Groundwater Application Review Summary Form

Application # G- 19062

GW Reviewer Phillip Marcy Date Review Completed: 03/04/2021

PUBLIC INTEREST REVIEW FOR GROUNDWATER APPLICATIONS

Water-Level Measurements in Nearby Wells

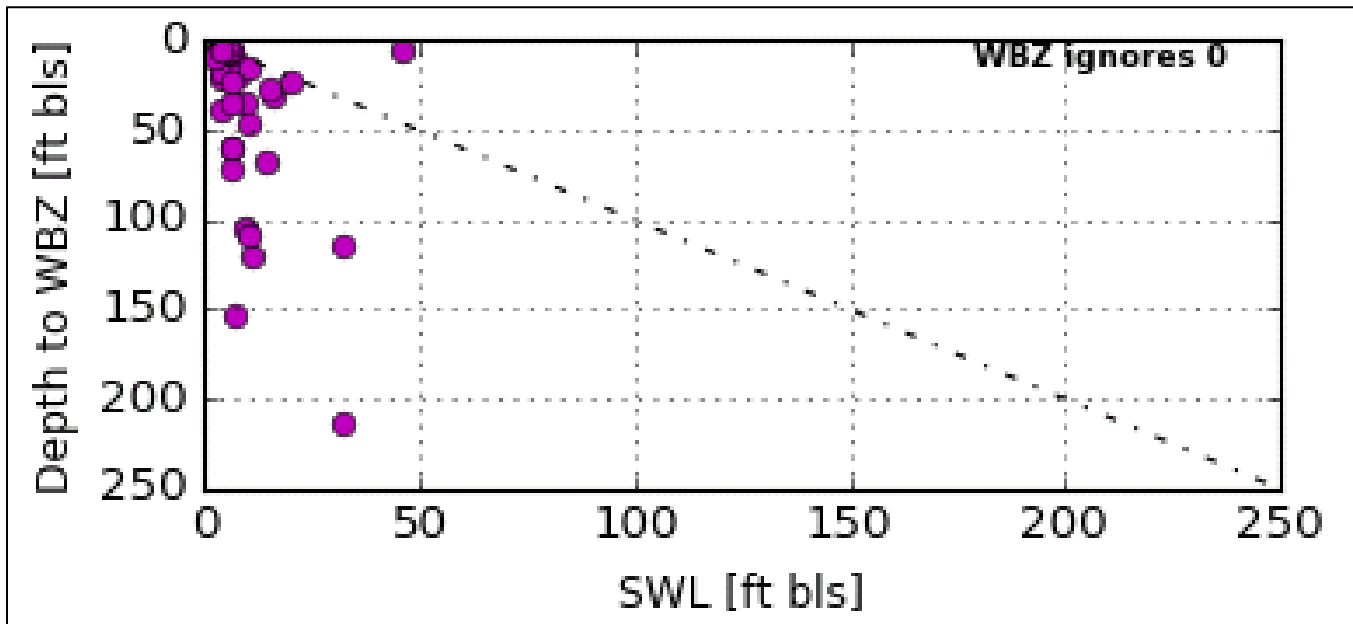
Nearby wells display modest declines over the past two decades.
